Project:	Panel Reference 2017HCC012 – DA 521/2017 Forster Civic Precinct Development
To:	Hunter & Central Coast Joint Regional Planning Panel (the Panel)
Attention:	Bruce Moore & Steve Andrews, MidCoast Council (Council)
From:	Assessing Officer, Chris Speak, City Plan Strategy & Development (CPSD)
Date:	19 September 2017

RESPONSE TO QUERY FROM THE PANEL: PANEL REFERENCE 2017HCC012 – DA 521/2017 FORSTER CIVIC PRECINCT DEVELOPMENT

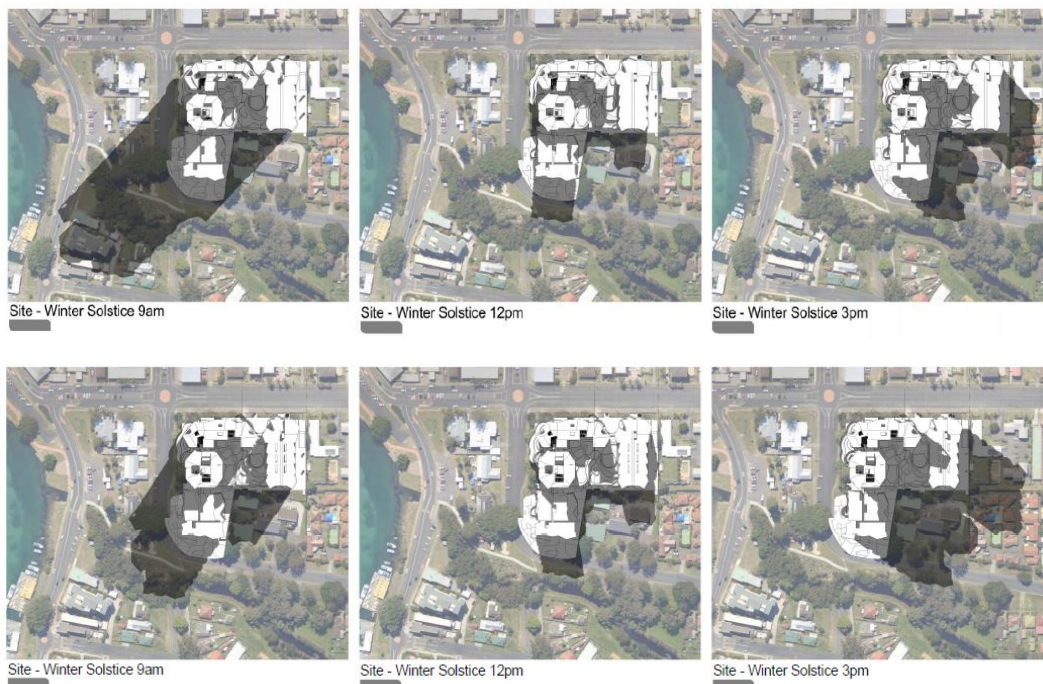
Is the 3pm winter shadow correct? (plan 5490.13) - it appears to be somewhat shorter than the 9am shadow. Could the accuracy of all shadow diagrams be confirmed, and if the 3pm one is wrong it needs to have some assessment.

TVS Architects reviewed the shadow diagrams in light of this request and noted that the software utilised for this detail included daylight saving. The shadows are therefore one hour earlier. The architect has resolved this by providing an updated shadow diagram.

CPSD has undertaken a review of this revised shadow diagram and notes that the 9am shadow has less impact than originally considered, while the 3pm shadow is slightly extended and reorientated.

Given the shift of the shadow relative to the orientation of the site, the assessment provided in the report maintains an adequate conclusion, being that the shadow diagrams indicate an acceptable impact.

Importantly, by way of an update, the dwellings to the south west are now demonstrated to not be affected. Whilst it was previously reported that the 3pm shadow will not cast over the solar panels of the neighbouring holiday park, the amendment to the diagram now indicates that the panels will be affected at 3pm. Nevertheless, acknowledging the original shadow diagram, the solar panel will continue to receive sunlight from 9am to 2pm.
